GB
SHIP NAME "MARKAB" REPORT Ant. No. 25236

The ANTWERP Surveyors report the vessel placed in dry dock, and the requirements of a PERIODICAL SPECIAL SURVEY (A), due 2.49, complied with at this time.

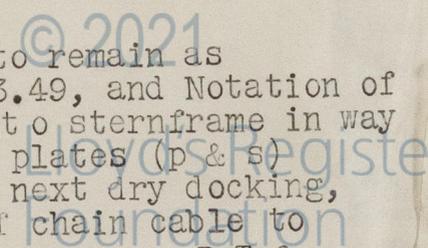
Sternframe at oxtter, as above, specially examined and found further fractured. The welding of upper edge of boss plates, to shell also found fractured. These have now been dealt with as shown on sketches.

The sternplate, as above, specially examined and found efficient.

The Surveyors recommend no further note be made of this item.
